Work Order ID 144335

Item Name: Crosstube Turning Detail

DART AEROSPACE LTD	Work Order: 144335
Description: Crosstube Assembly (206B High Fwd)	Part Number: D206-667-141
Inspection Dwg: D206-667-141 Rev: C	Page 1 of 2

DRAWING NO. D206-667-141	TITLE CROSSTUBE ASS'Y (206B HIGH FWD)	REV. C	DART AEROSPACE LTD ENGINEERING ORDER		D.E.O. NO. D206-667-141-C-1	SHEET NO. SHEET 1 OF 1	SCALE NTS
DRAWN <i>q</i>	CHECKED <i>ASS</i>	MFG. APPR. <i>JD</i>	APPROVED <i>MD</i>		DE APPR. <i>MD</i>		
DATE 11.07.15	DATE 11.07.20	DATE 11.07.21	DATE 11/07/21		DATE 11.07.21

DETAIL P
BONDING STRAP INSTALLATION 2 PL

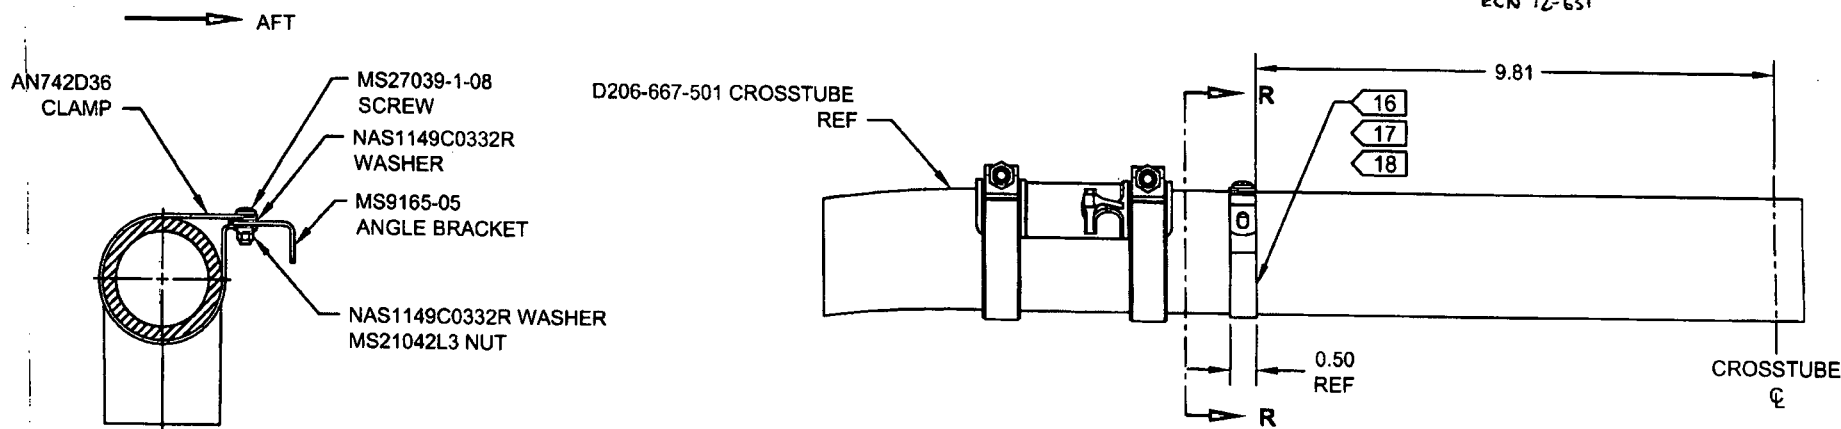
DRAWING NO. ID206-667-141	TITLE CROSSTUBE ASS'Y (206B HIGH FWD)	REV. C	DART AEROSPACE LTD ENGINEERING ORDER		D.E.O. NO. D206-667-141-C-2	SHEET NO. SHEET 1 OF 1	SCALE NTS
DRAWN AJS	CHECKED <i>[Signature]</i>	MFG. APPR. <i>[Signature]</i>	APPROVED <i>[Signature]</i>		DE APPR. <i>[Signature]</i>		
DATE 12.08.02	DATE 12.08.02	DATE 12.08.02	DATE 12.08.02		DATE 12.08.02

ADD ELECTRICAL GROUNDING STRAP

ITEM	QTY -141	PART NUMBER	DESCRIPTION
1	X	D206-667-141	CROSSTUBE ASSEMBLY (206B HIGH FWD)
⚡			
10	2	AN742D36	CLAMP
11	2	MS9165-05	ANGLE BRACKET
12	2	MS21042L3	NUT (OR MS21042-3)
13	2	MS27039-1-08	SCREW
14	4	NAS1149C0332R	WASHER (OR AN960C10L)

- 16) MASK AREA UNDER CLAMP PRIOR TO PAINTING
- 17) SEAL EDGES WHERE AN742D36 CLAMP MEETS WITH THE CROSSTUBE USING SIKAFLEX-241/-291 OR MIL-S-8802 CLASS B2 OR PROSEAL 890 SEALANT
- 18) PERFORM RESISTANCE CHECK TO ENSURE MAX RESISTANCE IS 10 MILLIOHMS
